<b>File Number</b>	PL 23-083	<b>Contact</b>	Kyle Deming	
<b>Type</b>	Special Use Permit – fill in a Floodplain	<b>Planning Commission Date</b>	5/9/2023	
<b>Deadline for Action</b>	<b>Application Date</b>	4/4/2023	<b>60 Days</b>	6/3/2023
	<b>Date Extension Letter Mailed</b>	4/19/2023	<b>120 Days</b>	8/2/2023
<b>Location of Subject</b>	North side of Keene Creek west of 57 <sup>th</sup> Avenue W. (Irving)			
<b>Applicant</b>	City of Duluth	<b>Contact</b>	Patrick Loomis, City Engineering	
<b>Agent</b>	SEH	<b>Contact</b>	Matt Bolf, PE, Project Manager	
<b>Legal Description</b>	Lots 15 & 16, Block 101 and Lots 15 & 16, Block 102, West Duluth 2 <sup>nd</sup> Division			
<b>Site Visit Date</b>	4/28/2023	<b>Sign Notice Date</b>	4/25/2023	
<b>Neighbor Letter Date</b>	4/20/2023	<b>Number of Letters Sent</b>	36

Special Use Permit for placement of fill in the Keene Creek floodway for Cross City Trail construction.

**CROSS CITY TRAIL - PHASE 3**  
DULUTH, MINNESOTA

RE: Cross City Trail Phase 3 Floodplain Impacts  
SEH No. DULUT 159621 14.00

**59TH AVE. WEST TO IRVING PARK**  
**PLAN AND PROFILE**

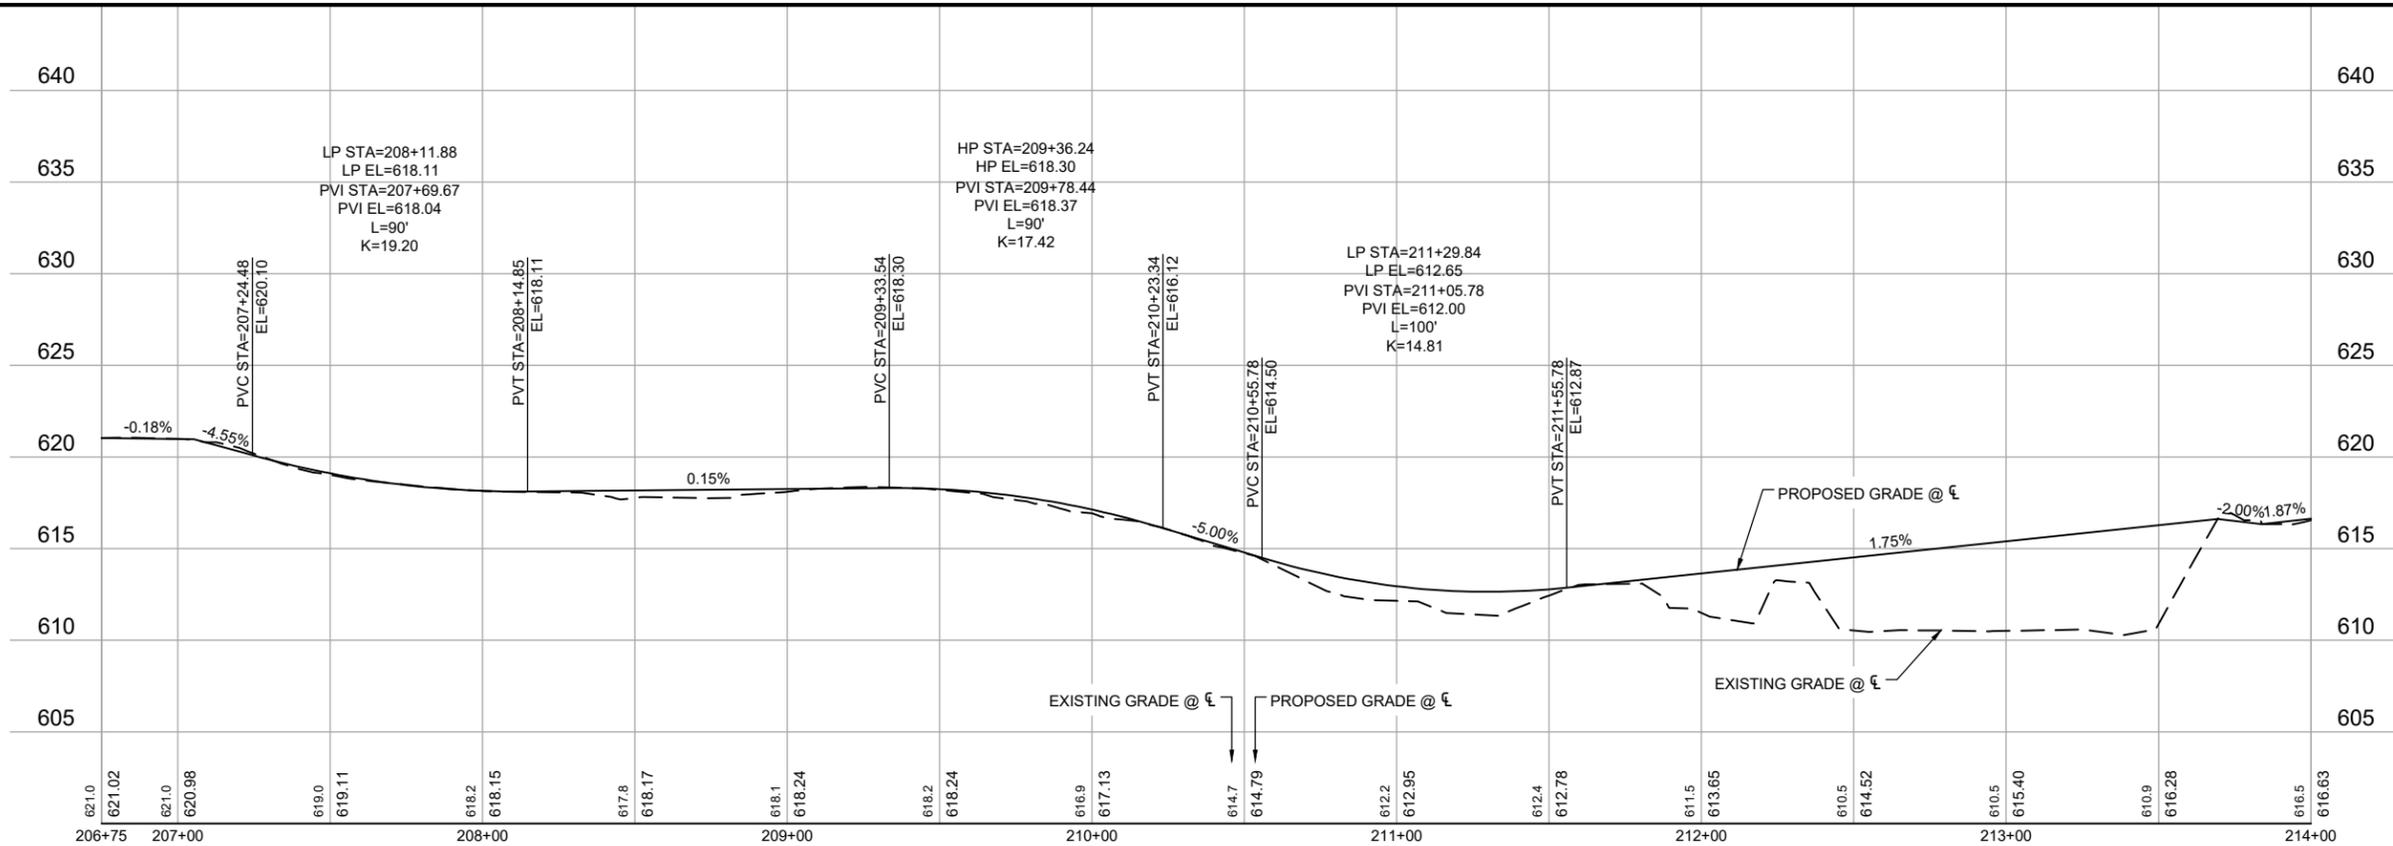
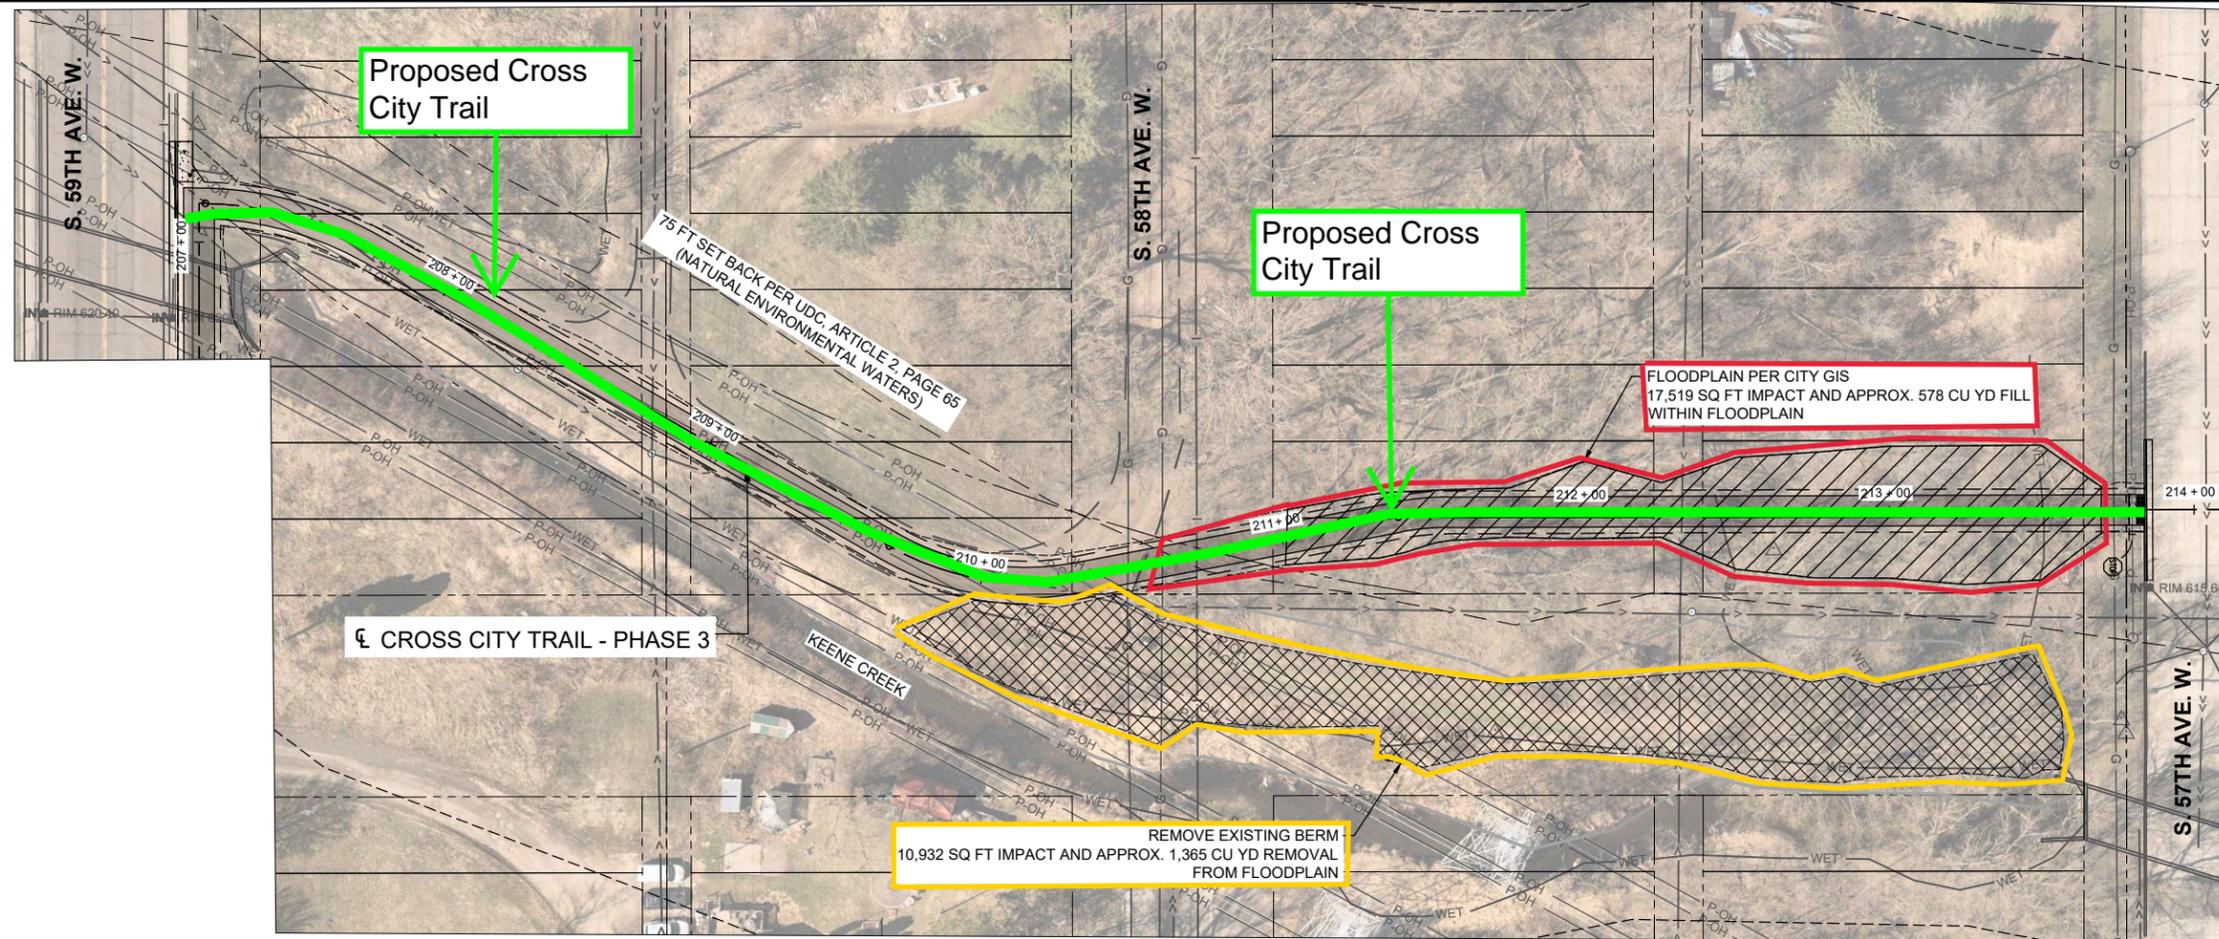
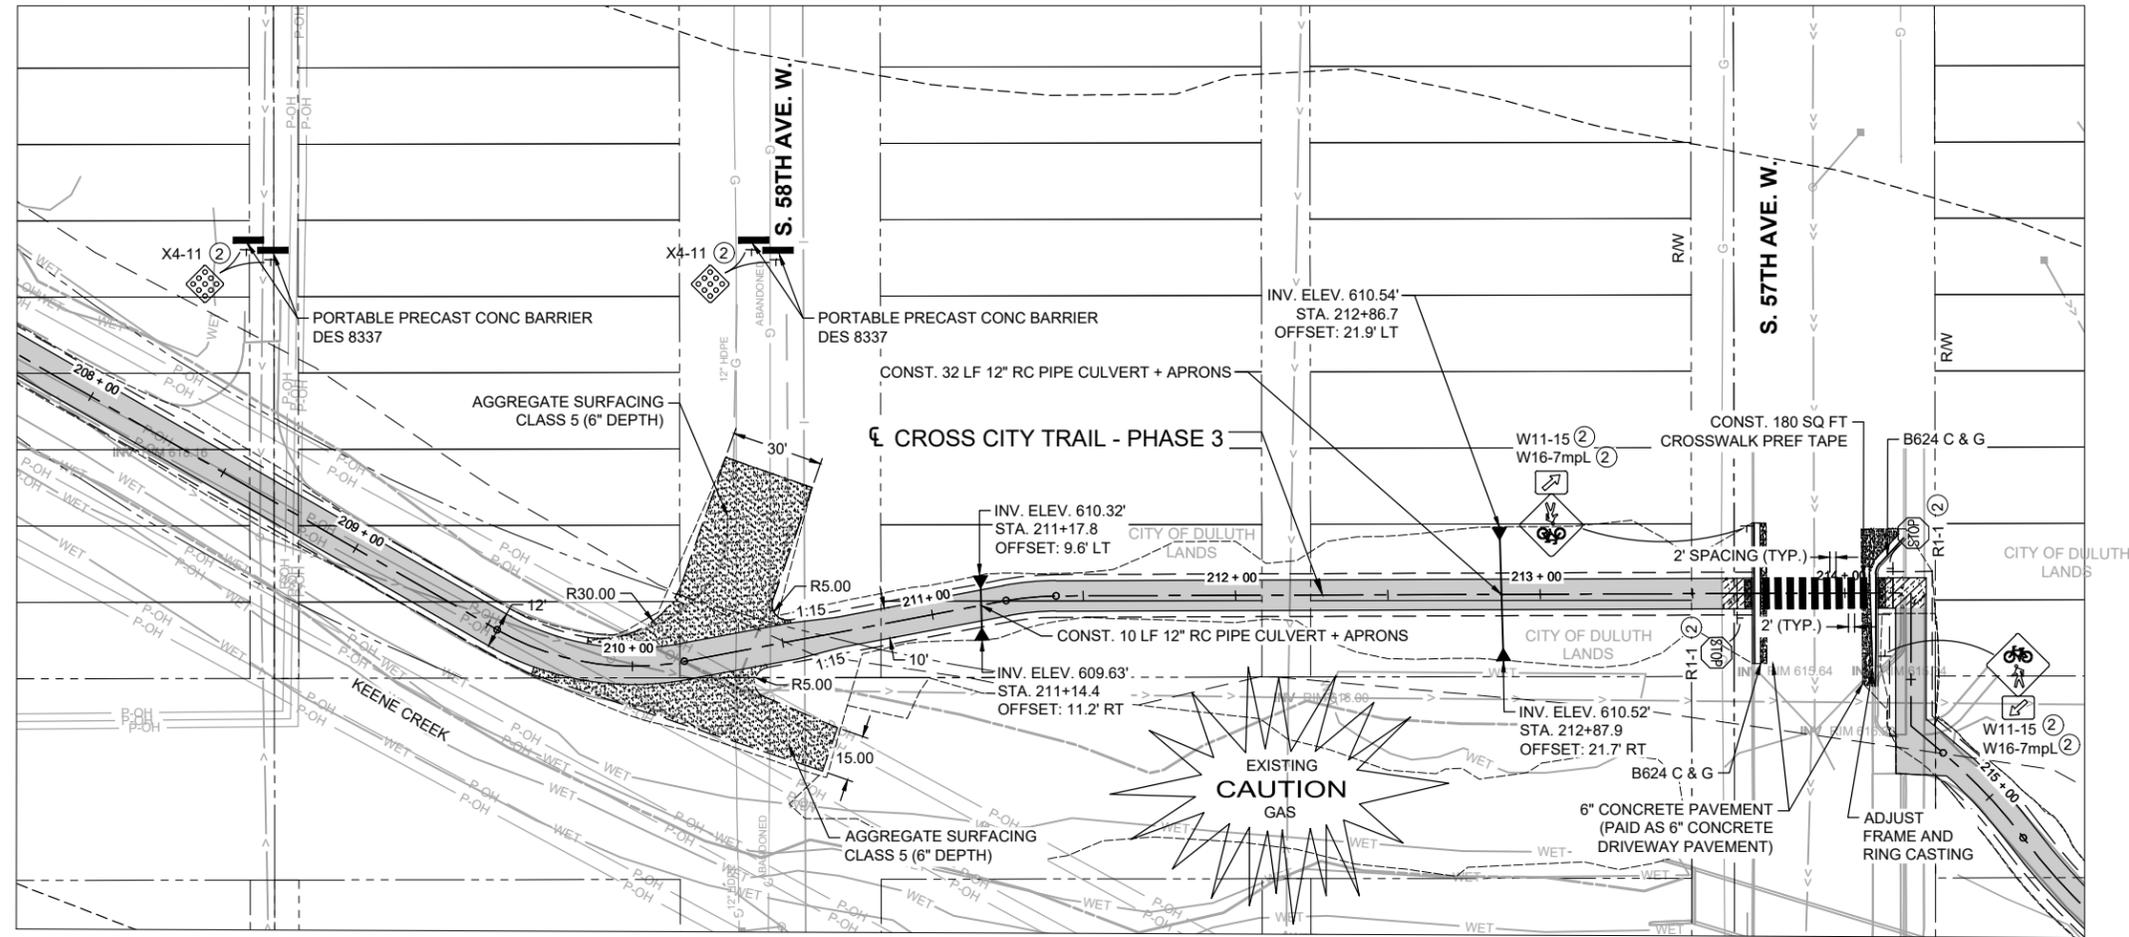
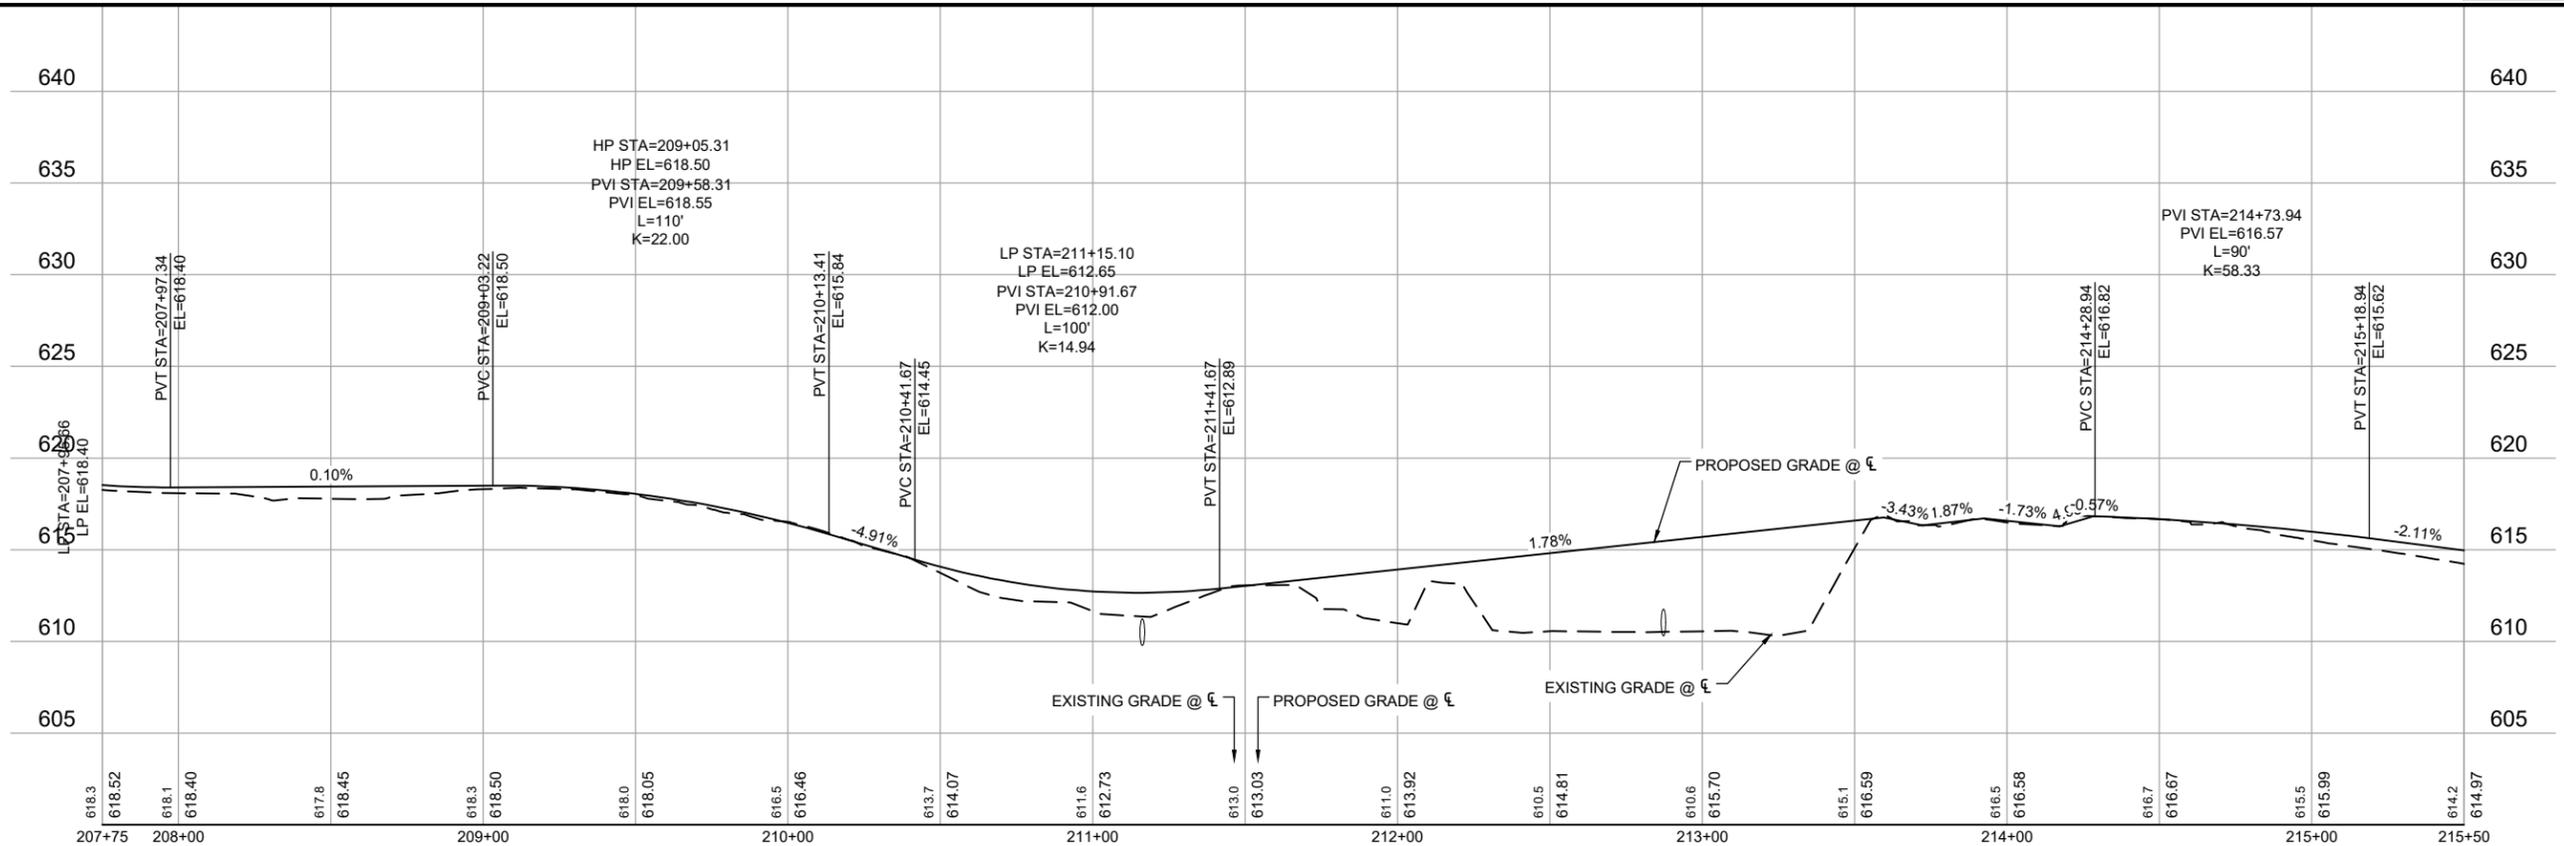
- 3.) Trail designs show placement of 578 cubic yards of fill to raise the grade for the trail. Offsetting the fill placement, plans show removal of 1,365 cubic yards of material from an existing berm along the creek from a previous trail.

- 5.) The trail engineer states “the trail was designed to minimize fill in the floodplain by elevating the trail only the amount needed to match the elevation of 57<sup>th</sup> Ave. W. In addition, slopes of 1:3 were used instead of the standard 1:4 to minimize fill.”

- 6.) The trail design includes two culverts placed at natural grade and at a shallow to flat slope to allow water to flow in either direction under the trail fill in order to equalize water moving through the floodplain.

- 1.) The project shall be limited to, constructed, and maintained according to plans by SEH entitled Cross City Trail – Phase 3, 59<sup>th</sup> Ave. West to Irving Park.
- 2.) Any alterations to the approved plans that do not alter major elements of the plan may be approved by the Land Use Supervisor without further Planning Commission review; however, no such administrative approval shall constitute a variance from the provisions of Chapter 50.

**EROSION CONTROL AND TURF ESTABLISHMENT PLAN**

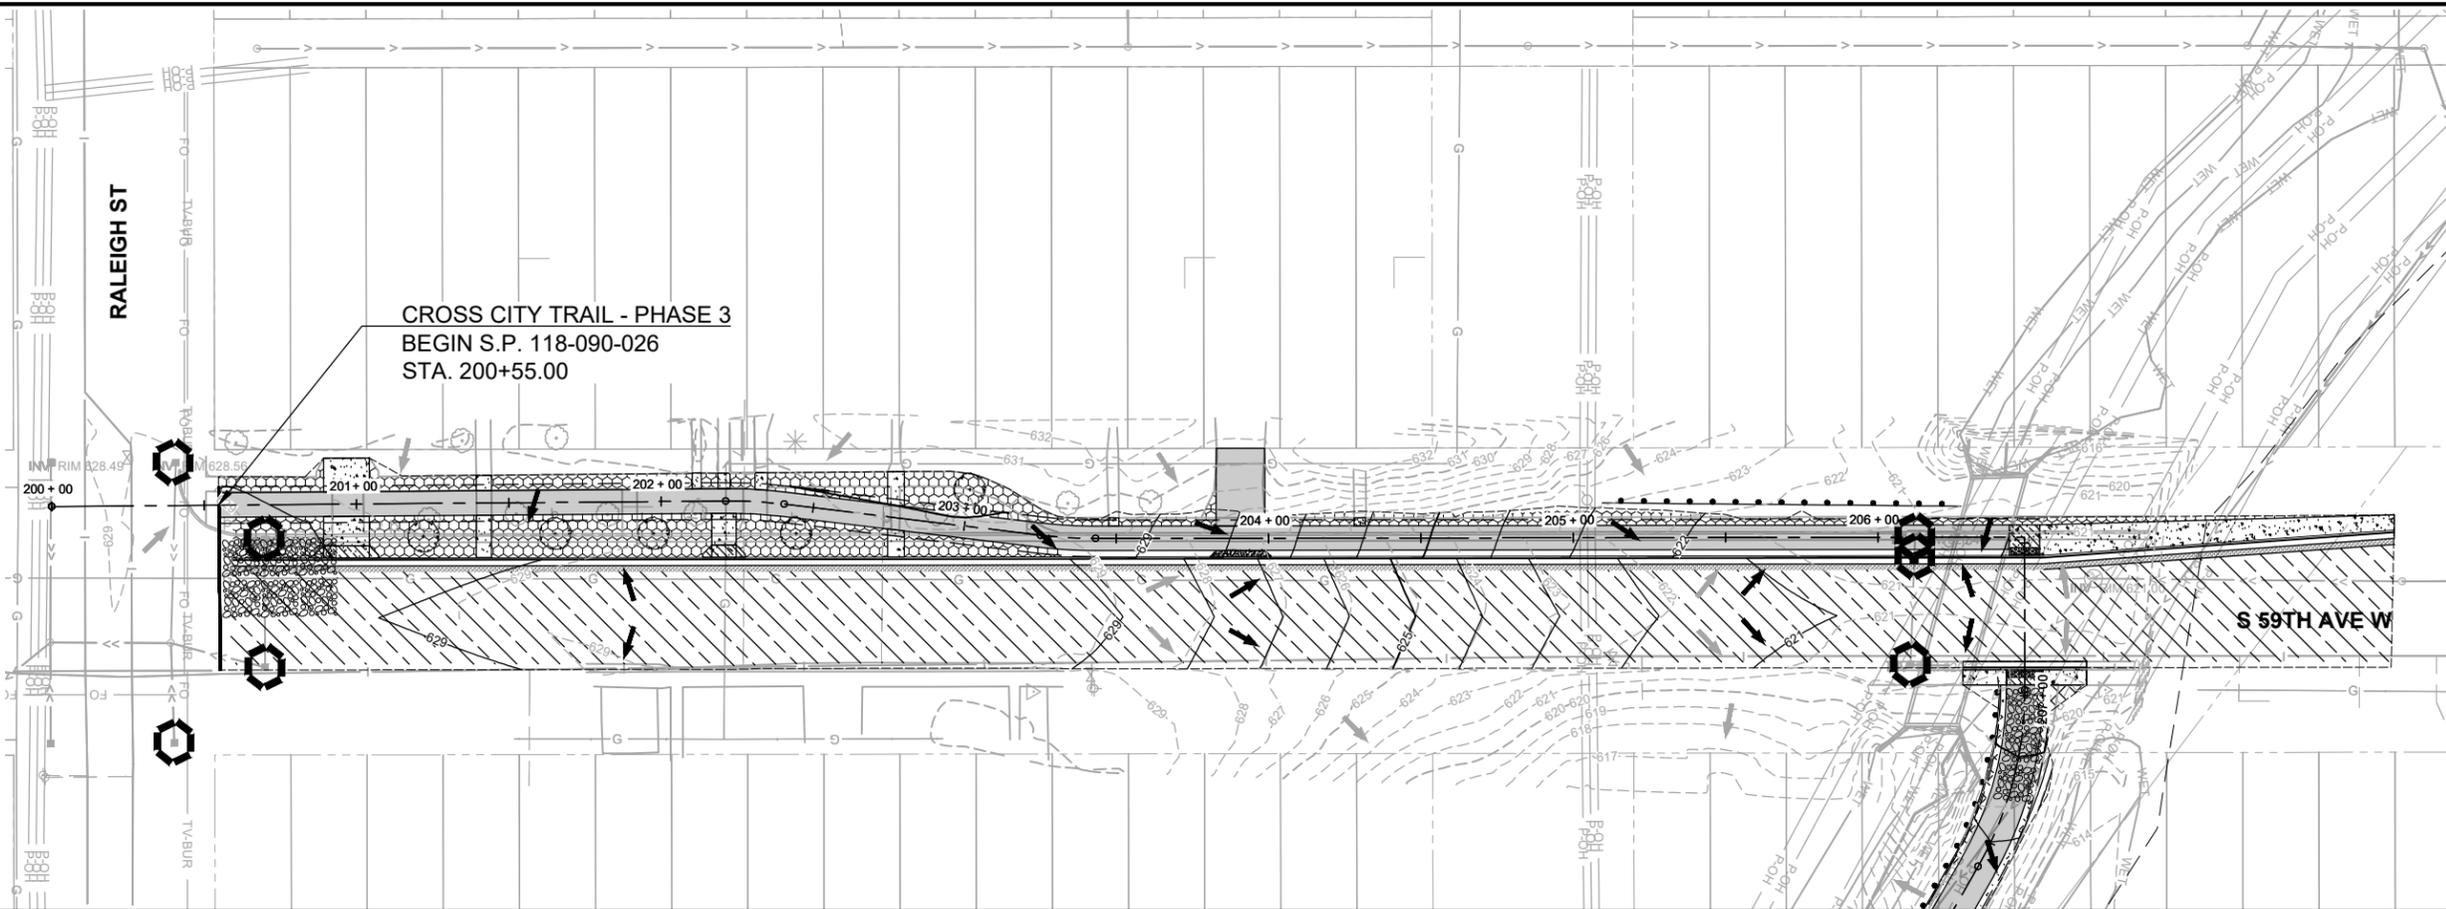
- 7.) The trail design includes seeding the slope to protect from erosion instead of using rip-rap due to the infrequency of flooding as well as reduction in hazards to trail users who may venture from the pavement.
